**Re: Docket No. 040-08006; License No. SUB-986
Kerr-McGee Corporation LLC (KMCLLC) Technical Center
Responses to NRC Region IV Decommissioning Plan Review Comments**

**Kerr-McGee Corporation L.L.C. (KMCLLC) Technical Center
Responses to NRC Region IV Decommissioning Plan Review Comments**

Figure 4.1

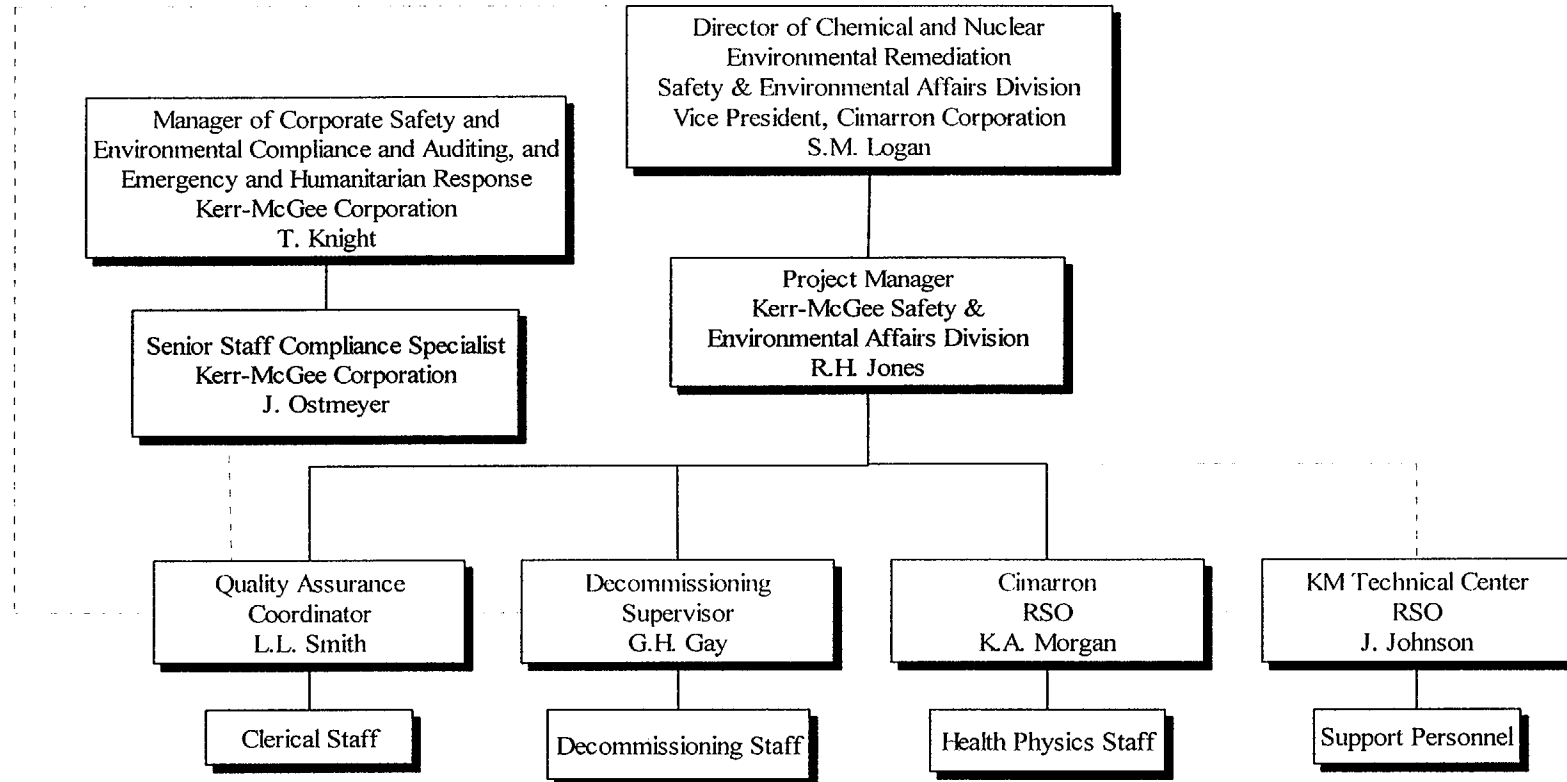
Finally, retirements and a recent reorganization within the Kerr-McGee Safety and Environmental Affairs Division necessitate changes to the Technical Center decommissioning organization. Russell Jones will now serve as the Project Manager and

will report to Mike Logan who is the Director of Remediation. In addition, Jeff Ostmeyer, Senior Staff Compliance Specialist who reports to Tom Knight, will provide audit assistance. Attachment 4 contains the revised organization chart for the Technical Center decommissioning project.
